## API Ballot id# 5608 SC5 TGOCTG

<b>Work Item</b>	2440—Back-adopt ISO 13680:2020 as API SPEC 5CRA Second Edition
<b>Distribution-type</b> [Ballot, Comment-only, Recirculation, Re-ballot, etc.]	Ballot (acceptance of incorporating API/SC5 Work Item's)
<b>Other Impacted Documents</b>	NA
<b>Revision Key</b>	Modifications to ISO 13680:2020 shown in Track Changes as: — Additions in <u>underlined BLUE</u> — Deletions in <del>stricken RED</del>

# **Corrosion-resistant Alloy Seamless Products for Use as Casing, Tubing, Coupling Stock and Accessory Material**

**API SPECIFICATION 5CRA  
SECOND EDITON, [month][year]**

Figure B.4—Hardness test

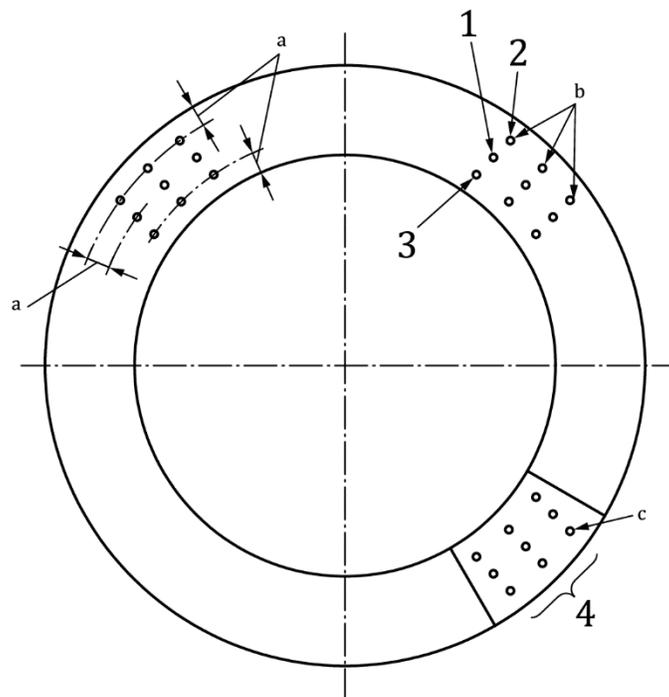
A ~~single indentation~~ test block shall be tested in one quadrant. A row of three hardness indentations shall be made at required locations (outer, midwall, inner as applicable) and the hardness numbers shall be averaged to give one mean hardness number for each location. An illustration is given in Figure B.4, key item 4.
